CITY OF SAN ANTONIO
CAPITAL IMPROVEMENTS MANAGEMENT SERVICES DEPARTMENT

PROJECT NAME: Callaghan Road – Culebra to Commerce
PROJECT NO. 40-00007

DATE December 13, 2010

ADDENDUM NO. 2

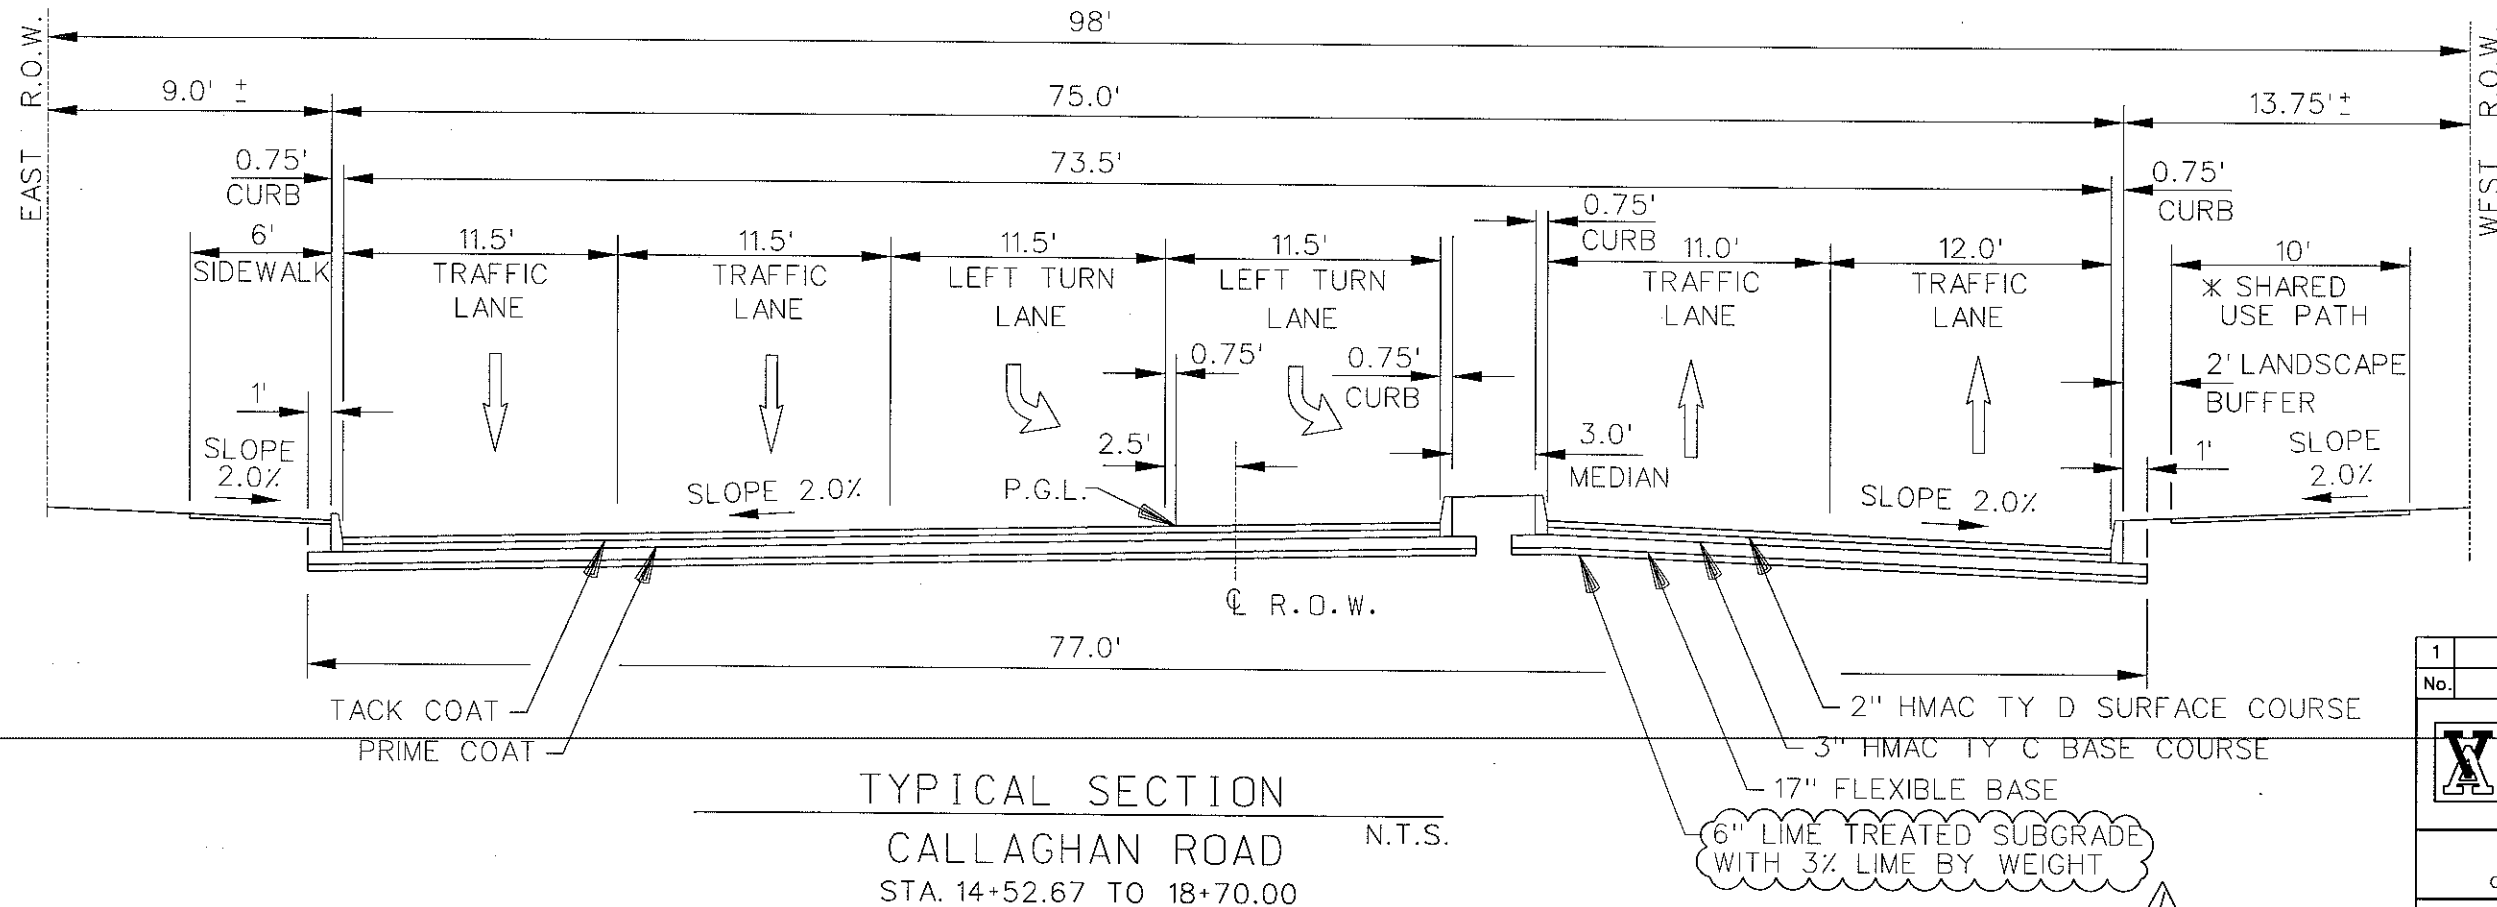
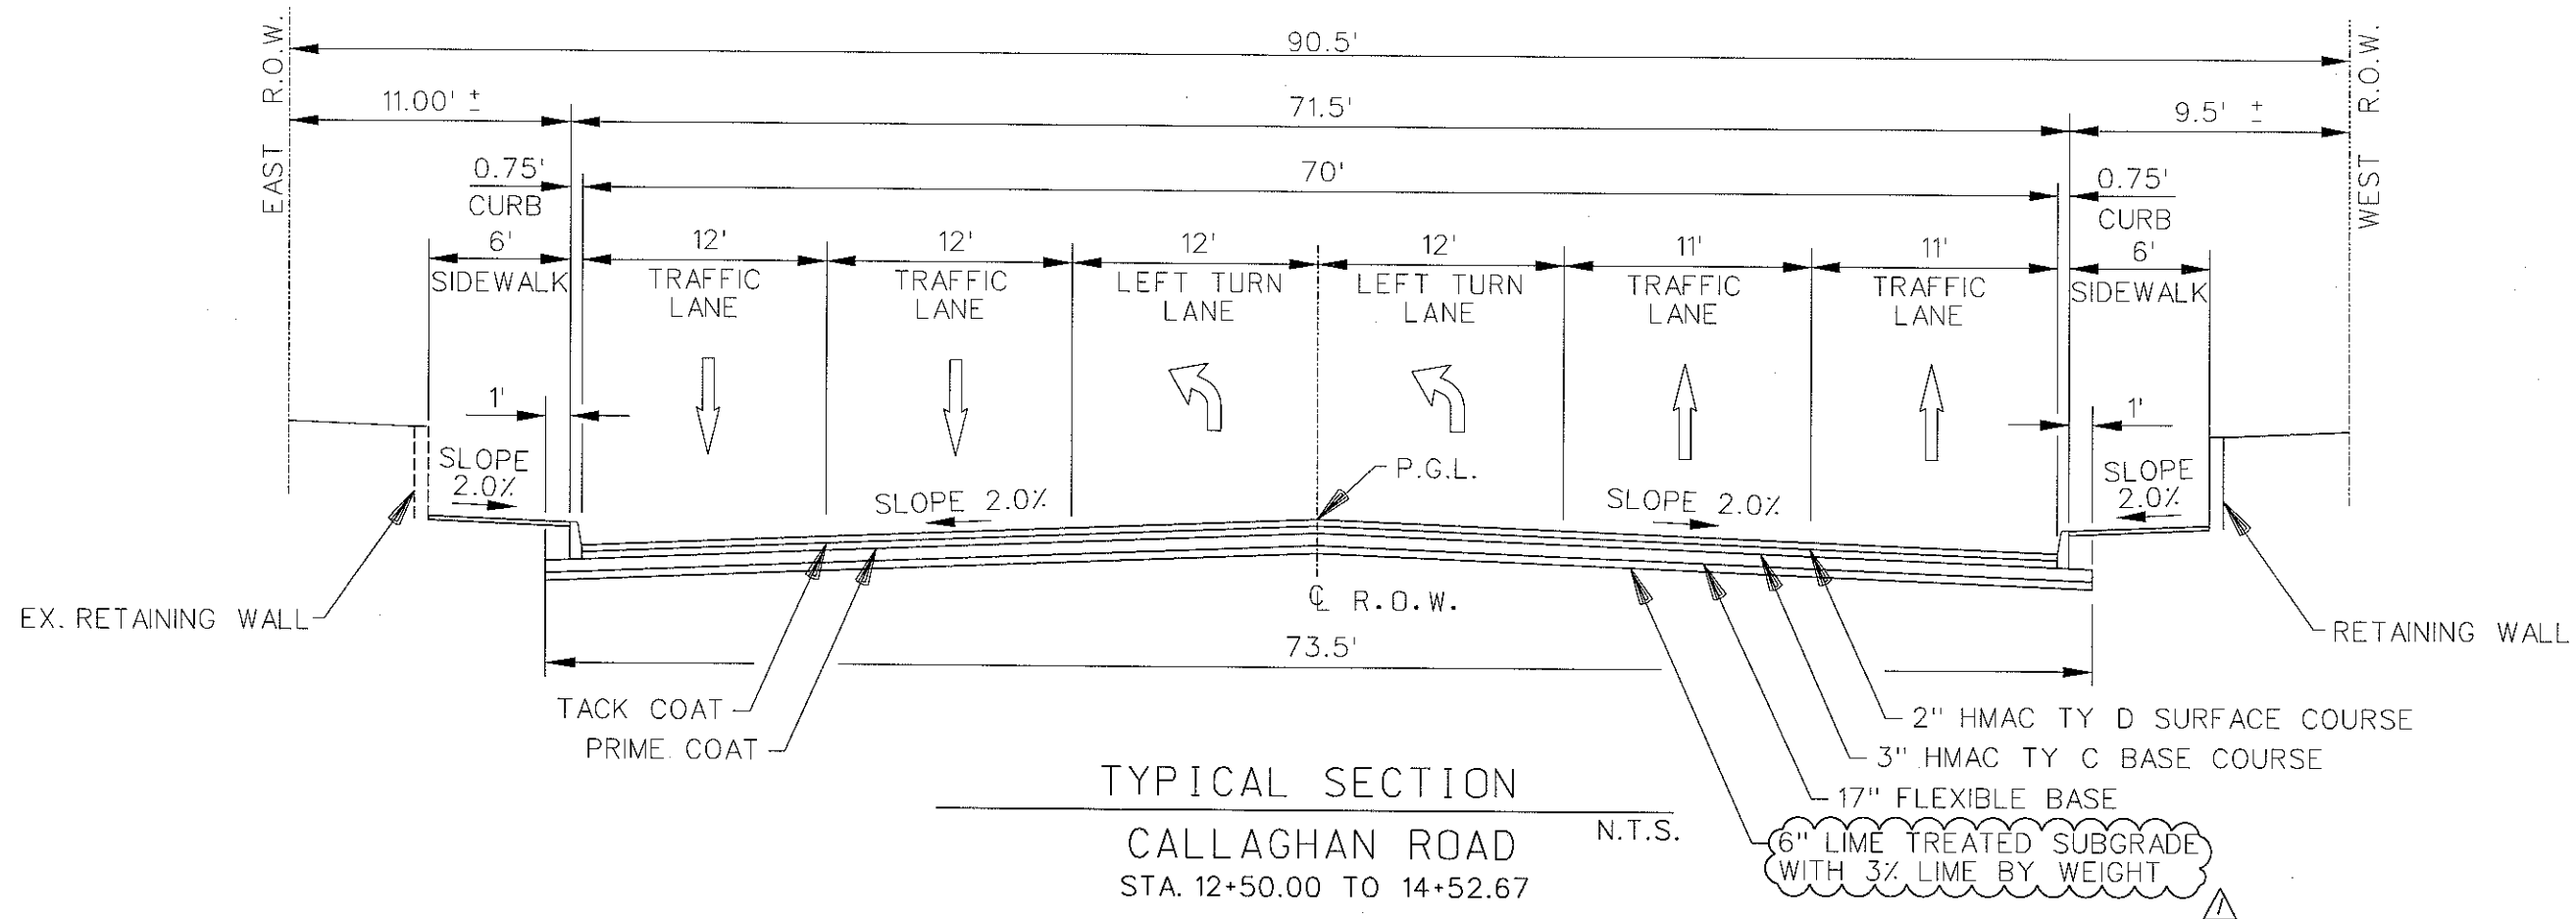
1. What is the lime application rate for the project and will the cost of the lime material be paid under a new bid item?

The lime application rate is 3 percent by weight. This is provided in the geotechnical report and has been added as a note to the construction documents. Lime shall be paid for under Item 108.2 Lime. See Sheets 16-22.

TRAFFIC CONTROL PLAN
TYPICAL SECTIONS

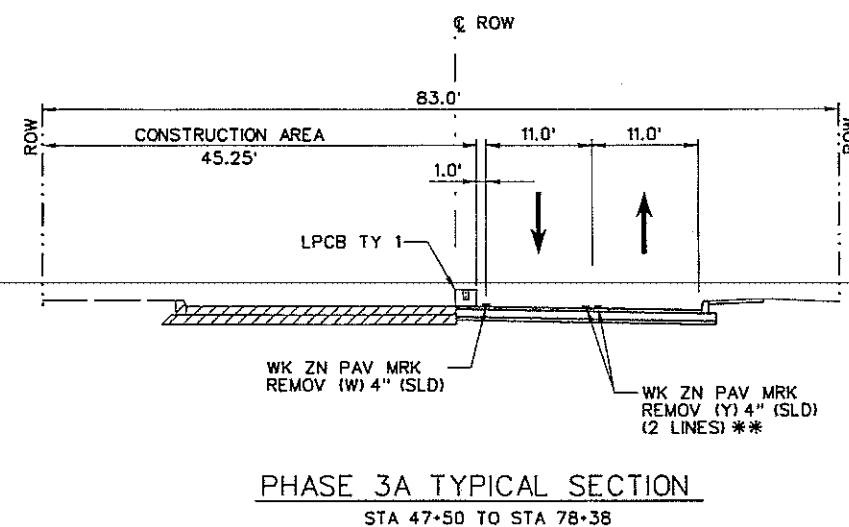
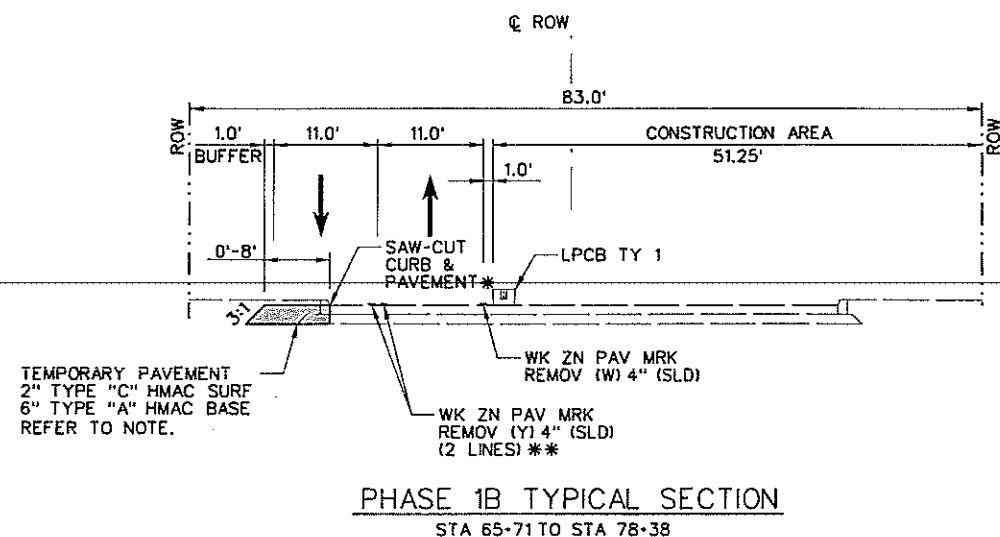
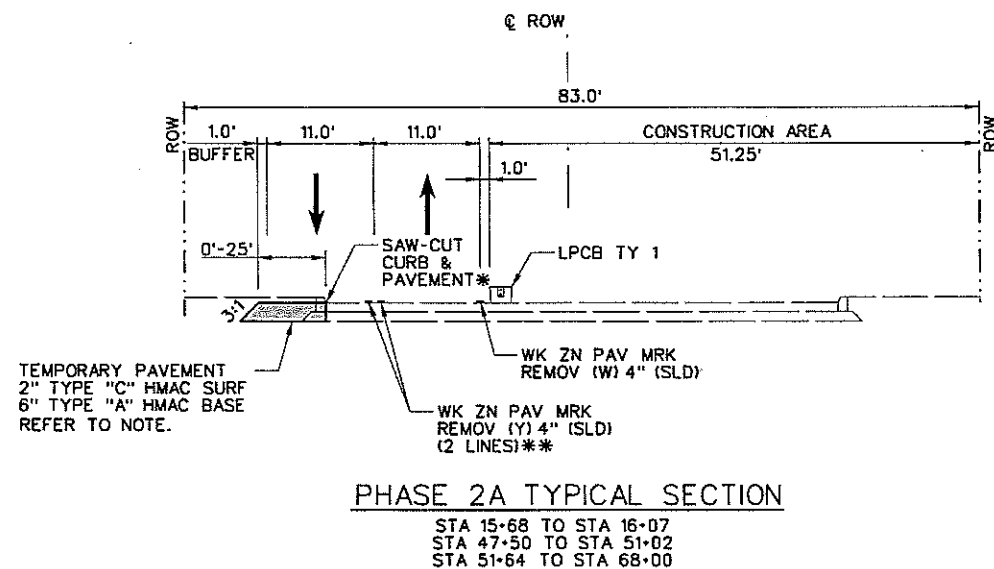
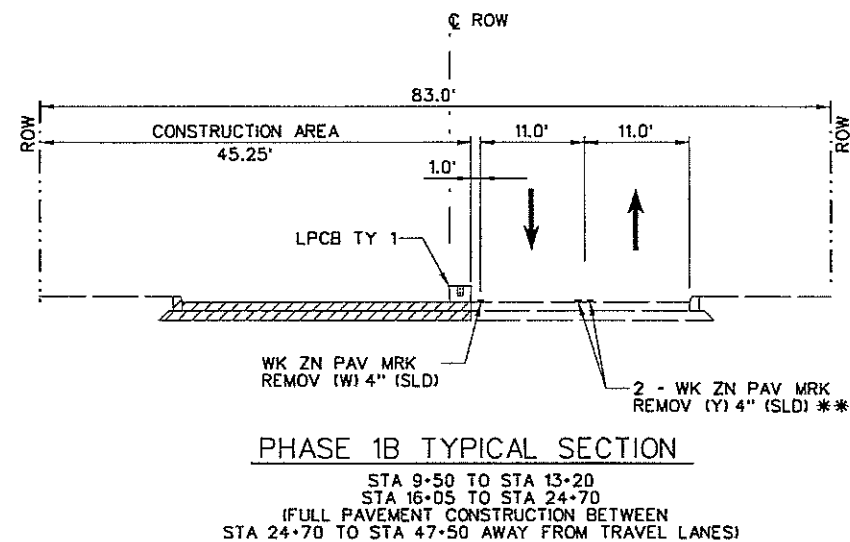
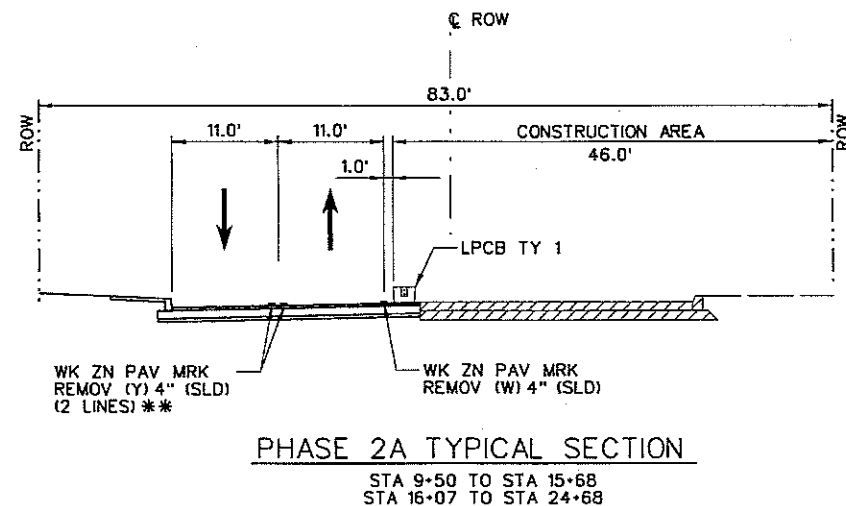
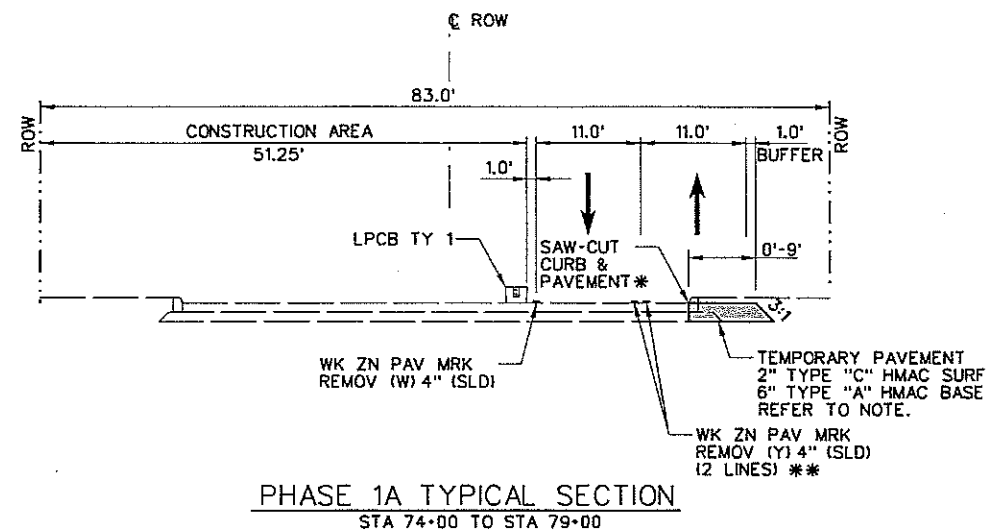
2. Reference Sheet 34; we assume the 3:1 sloped edge of the temporary pavement is included in the measurement of payment for Bid Items # 205.1 & 205.3. Please confirm.

The 3:1 slope is included in the measurement of payment. We went ahead and added a note to the typical sections to address any confusion.

NOTE:
THE TEMPORARY PAVEMENT 3:1 SLOPE WILL BE
CONSIDERED INCIDENTAL TO BID ITEMS:
205.1 "HOT MIX ASPHALTIC PAVEMENT TY A (6")
AND 205.3 "HOT MIX ASPHALTIC PAVEMENT TY C (2")
